**STATE OF CONNECTICUT
CONNECTICUT SITING COUNCIL**

**APPLICATION OF CELLCO PARTNERSHIP,
d/b/a VERIZON WIRELESS FOR A CERTIFICATE
OF ENVIRONMENTAL COMPATIBILITY AND
PUBLIC NEED FOR THE CONSTRUCTION,
MAINTENANCE AND OPERATION OF A
WIRELESS TELECOMMUNICATIONS
FACILITY AT THE GAYLORDSVILLE
VOLUNTEER FIRE DEPARTMENT, NEW MILFORD,
CONNECTICUT**

:
:
: **DOCKET NO. 347**
:
:
:
:
:
:
:
: **NOVEMBER 28, 2007**

PRE-HEARING INTERROGATORIES DIRECTED TO THE APPLICANT

**Proposed Verizon Wireless RF Coverage
New Milford NW Site at 120'
With Surrounding Coverage**

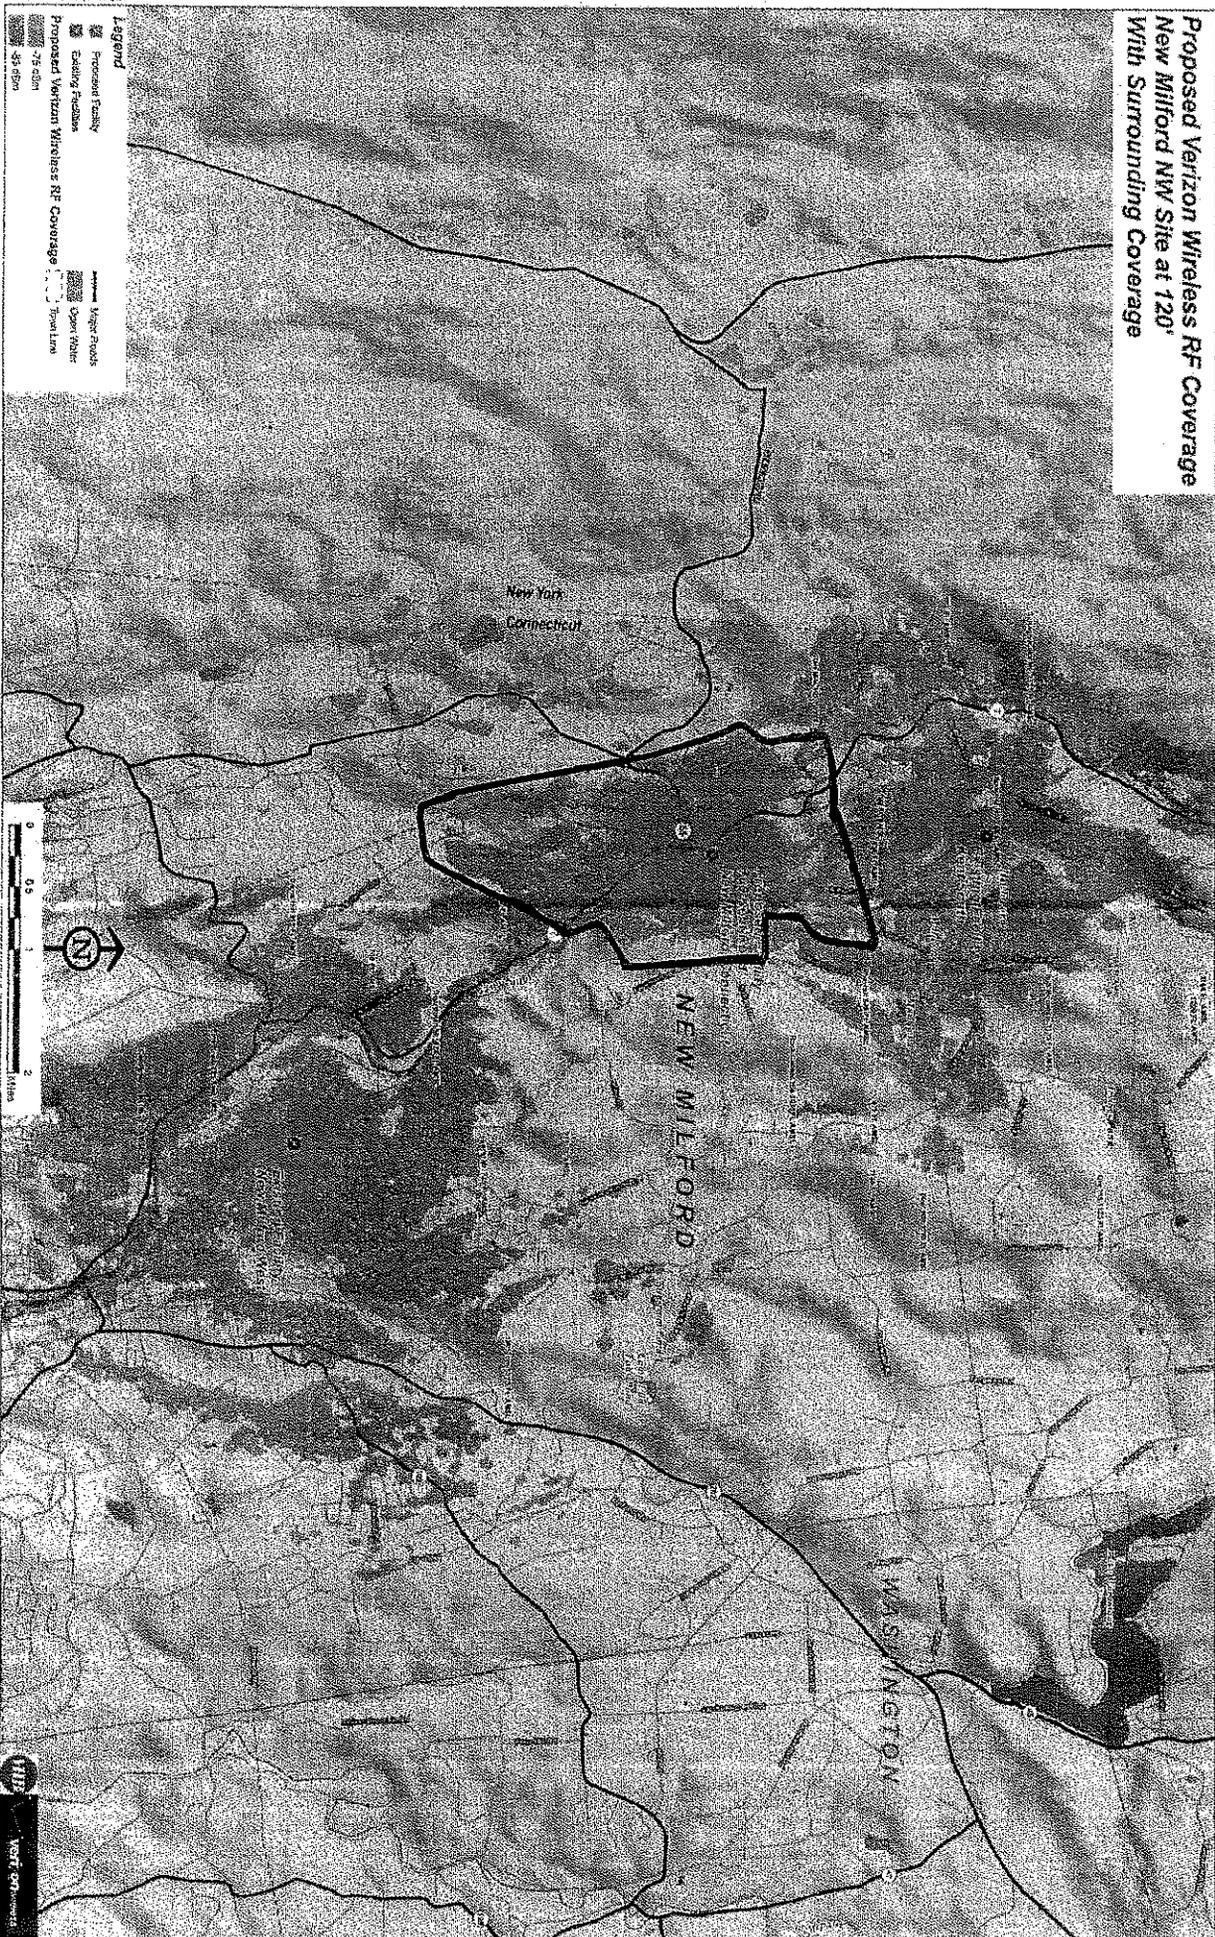
34. Please create a document similar to that attached hereto as Exhibit A which accurately (as opposed to our estimated hand drawn boundary) depicts on one plot the area of new service provided by the Applicant's proposed facility.
